**APPENDIX 4B**

**DETAILED DRAWINGS FOR THE 200 AREA EFFLUENT TREATMENT FACILITY  
CONTAINER STORAGE AREA AND TANK SYSTEMS**

1. ECN 647892

ECN 647892, PG 9 OF 27  
14-2-89039, SH 1

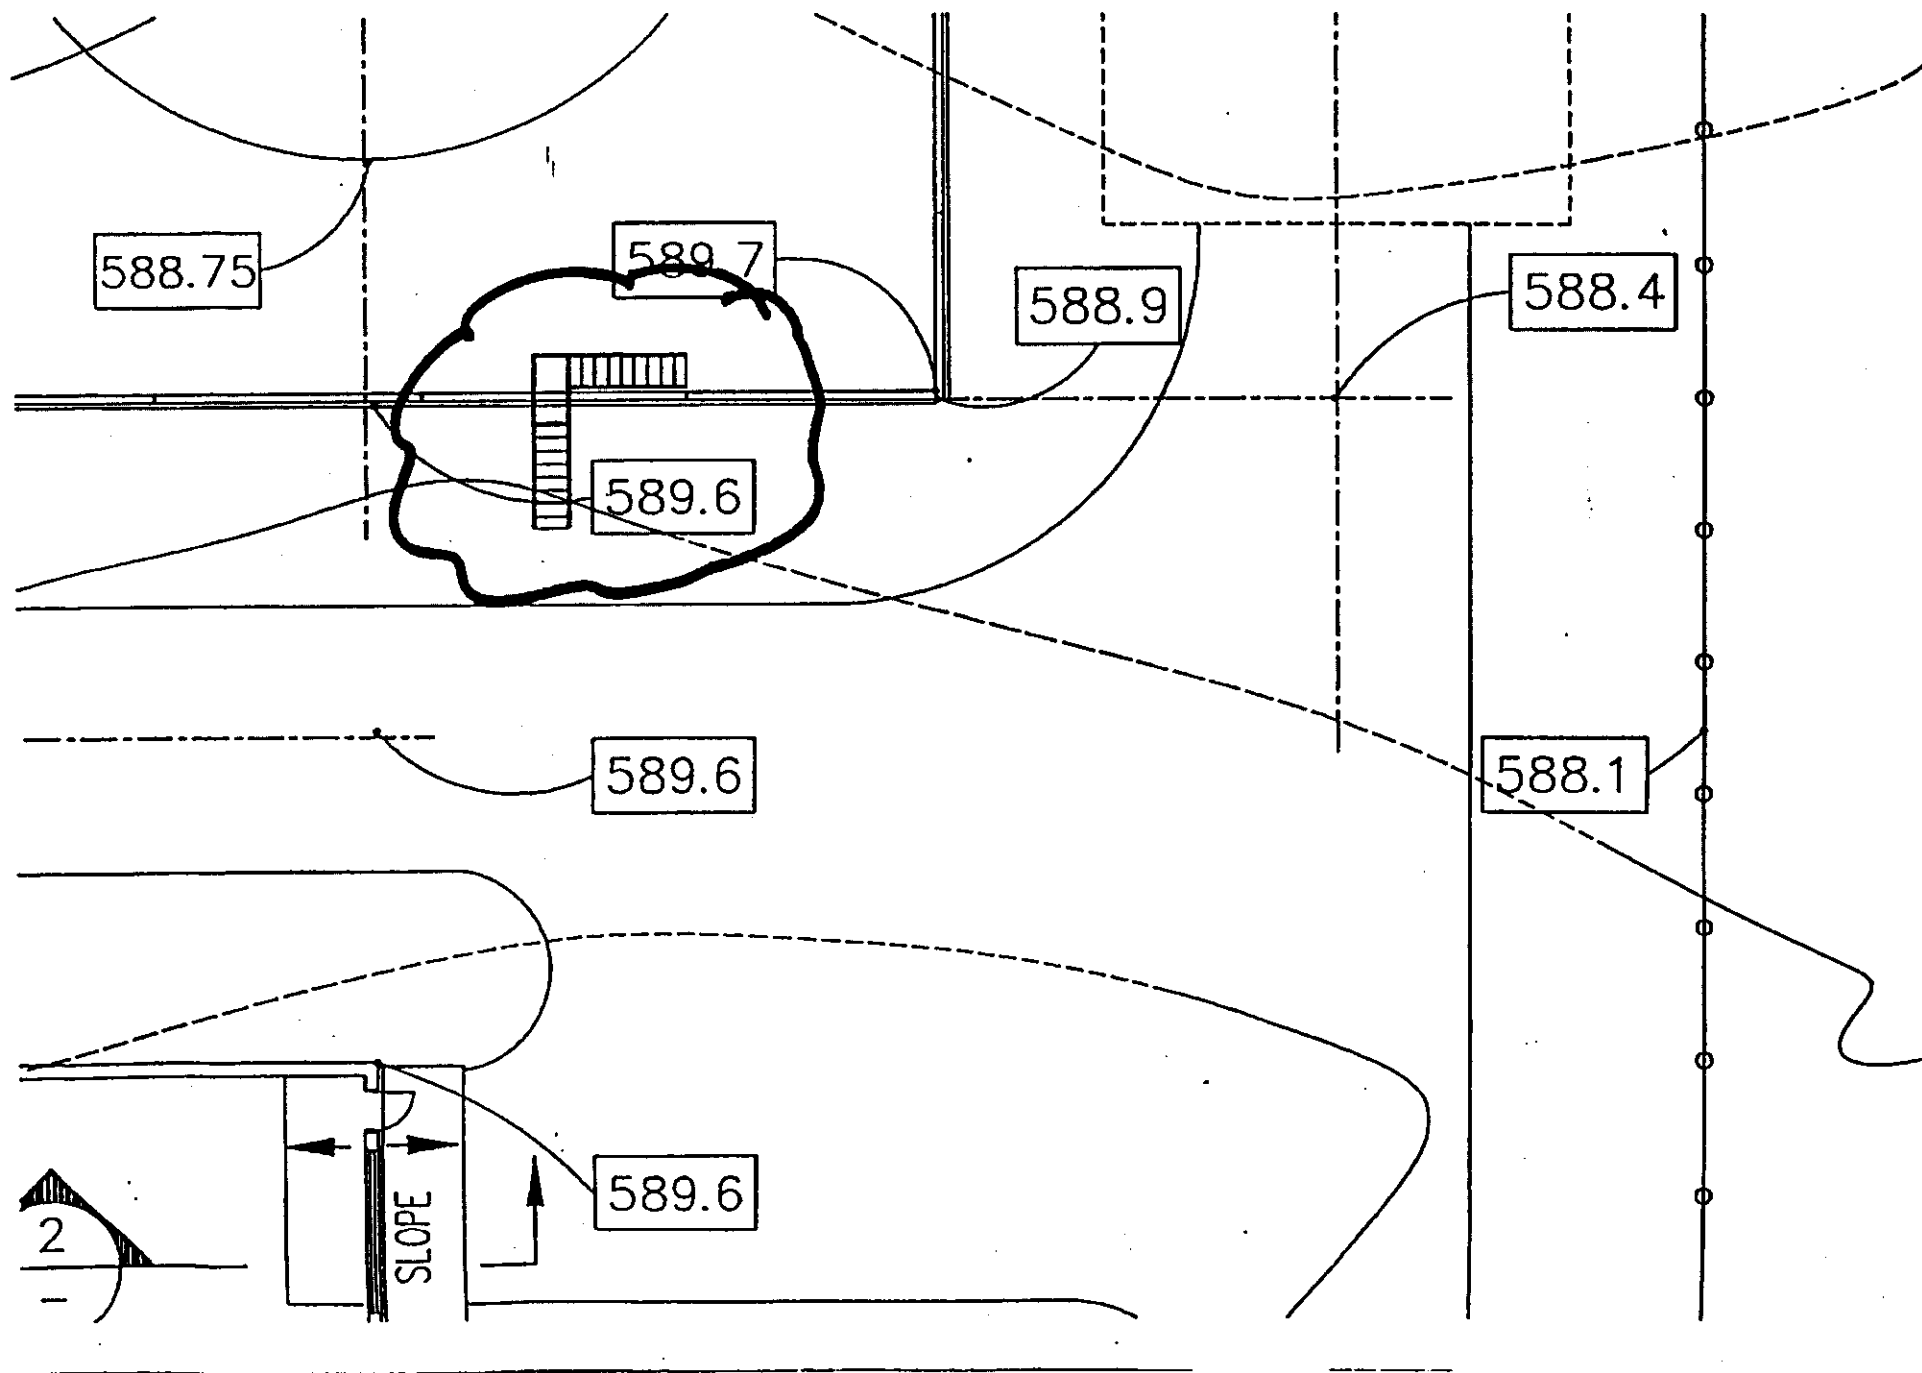
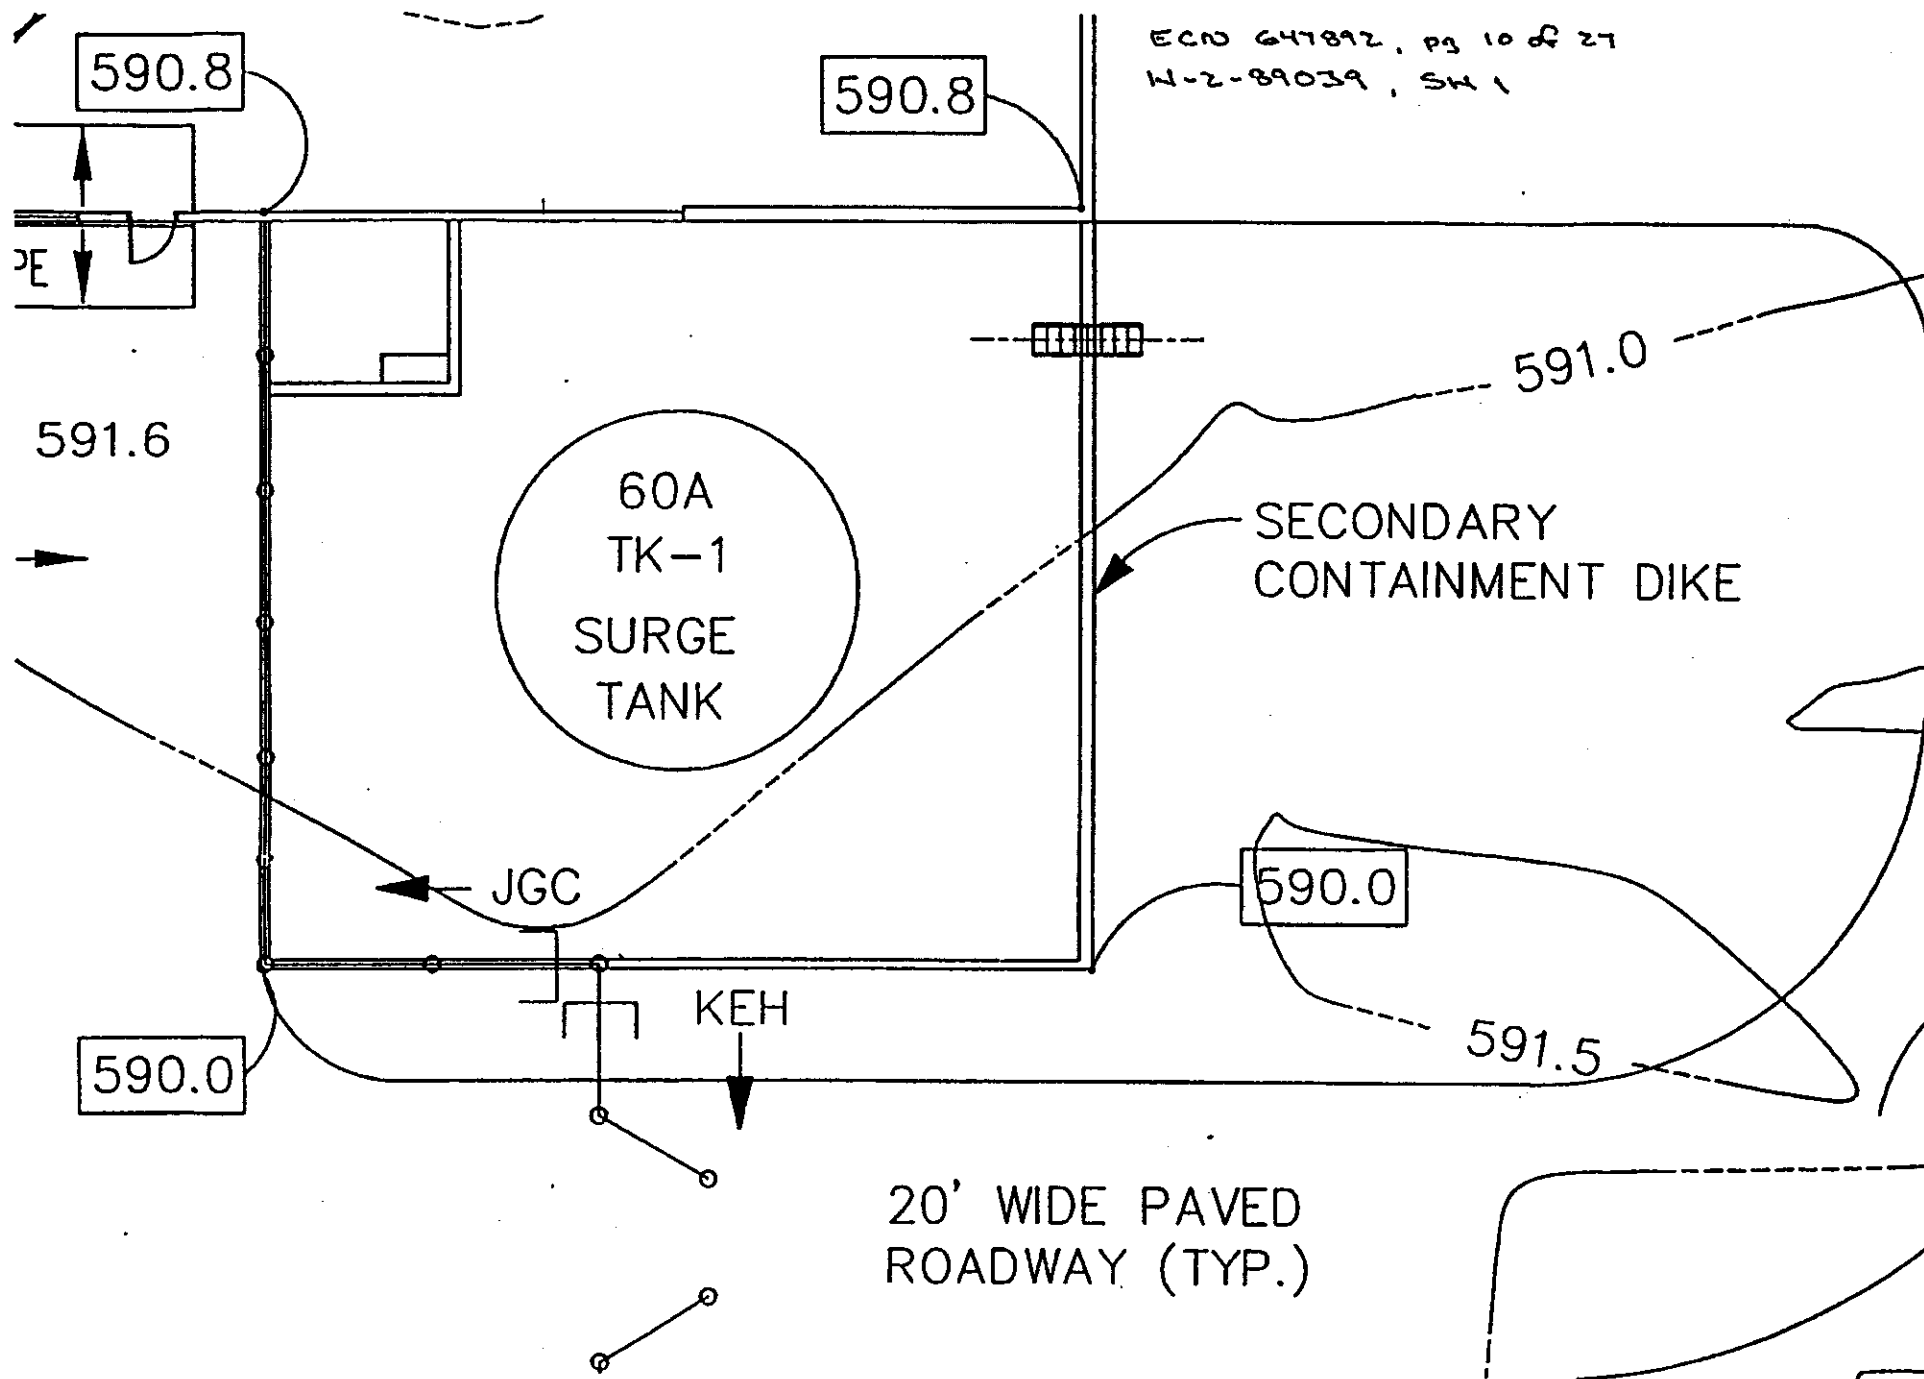
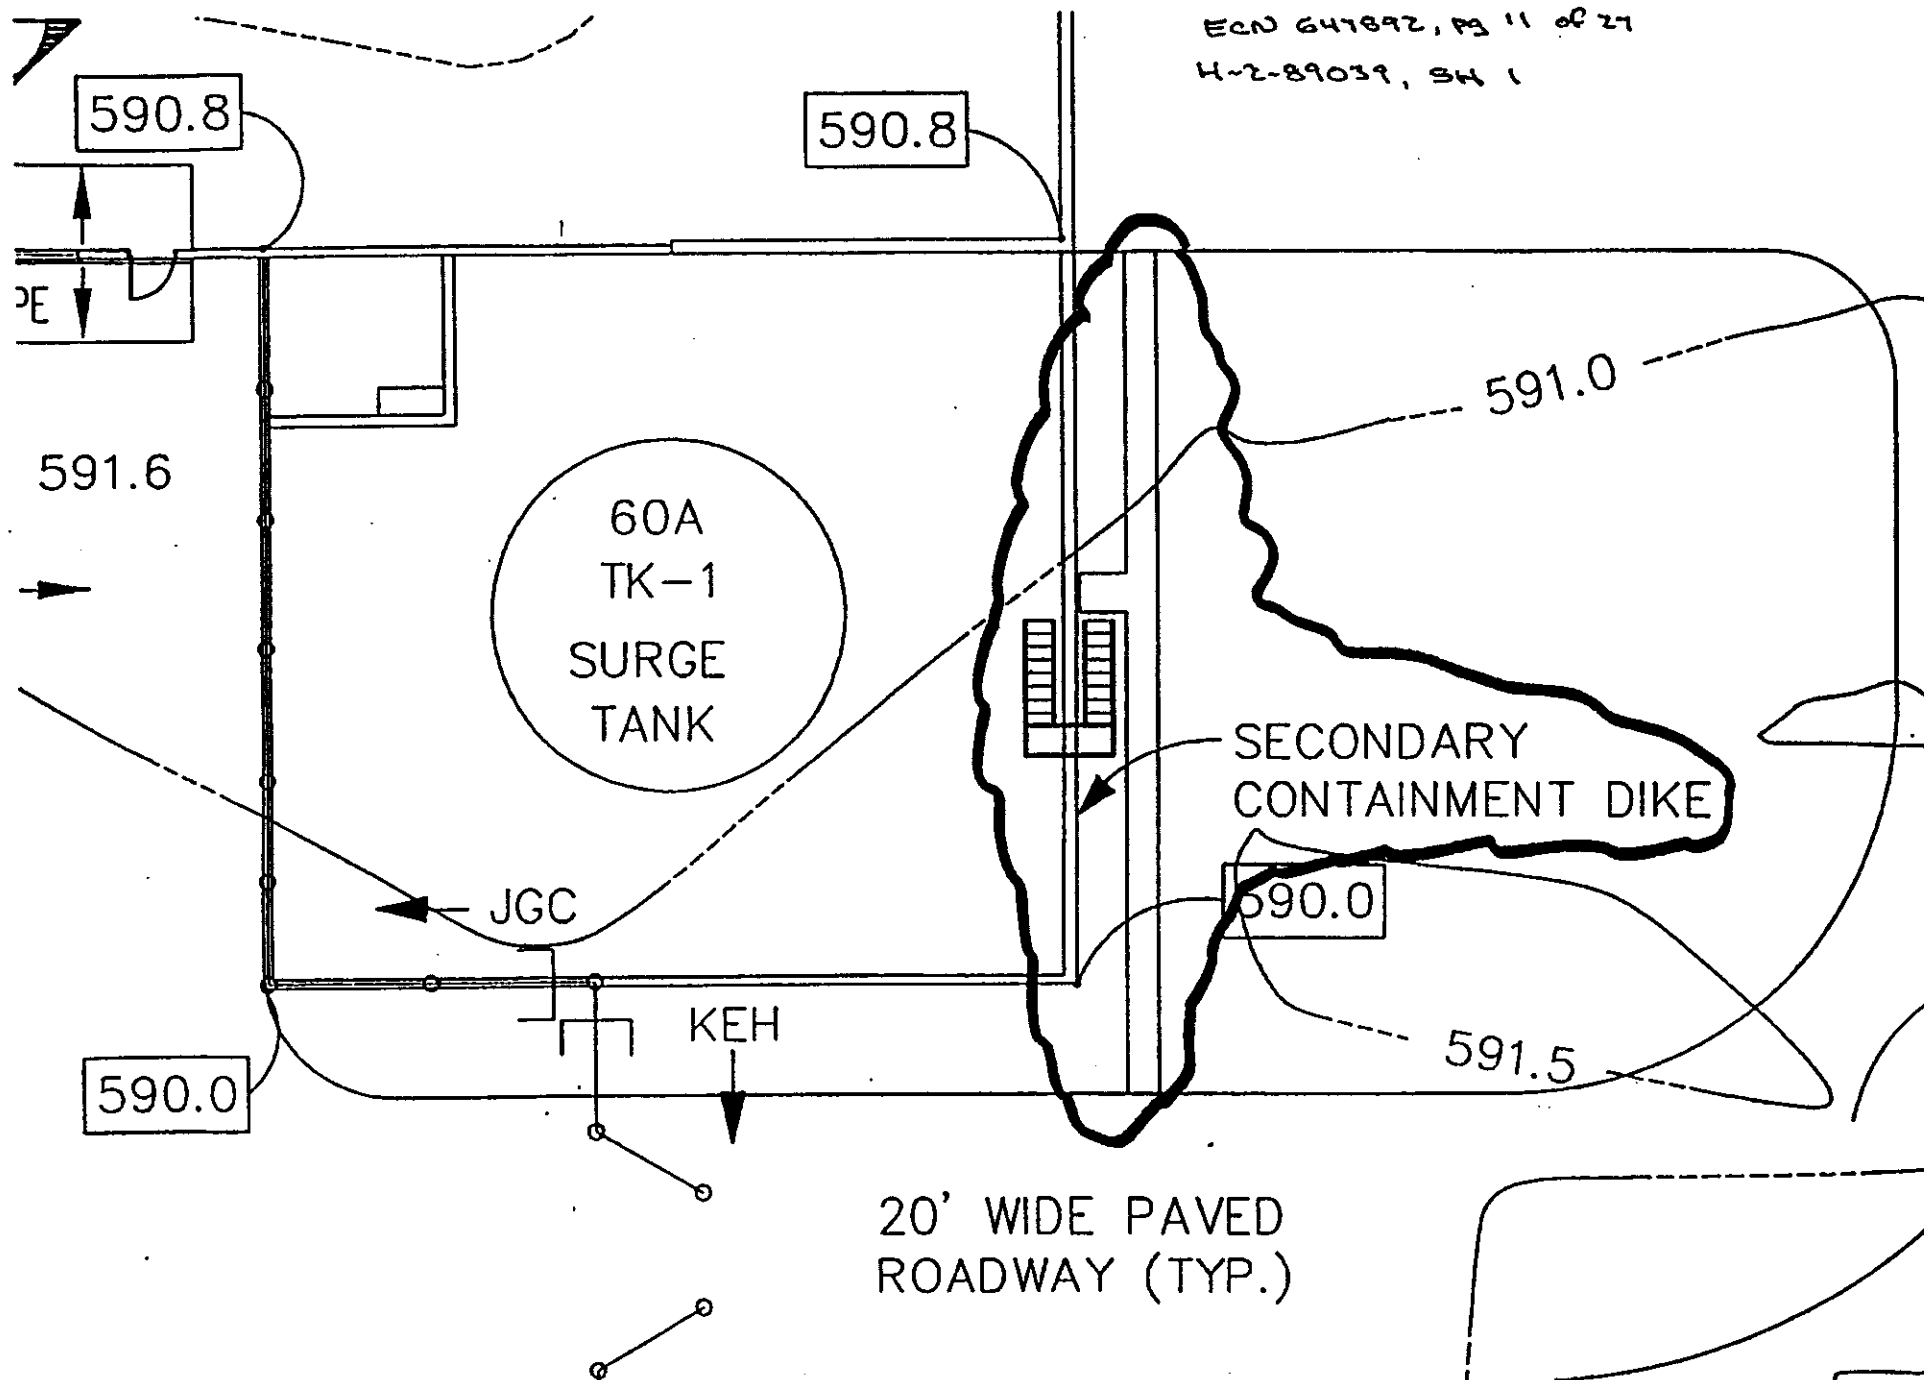
- H-2-89033, Sh 1, Zone D-3: Replace ladder with stairway.
- H-2-89036, Sh 1, Zone E-4: Replace ladder with stairway.
- H-2-89039, Sh 1, Zone B-4: Replace ladder with stairway & show new sidewalk.  
Zone E-4: Replace ladder with stairway.
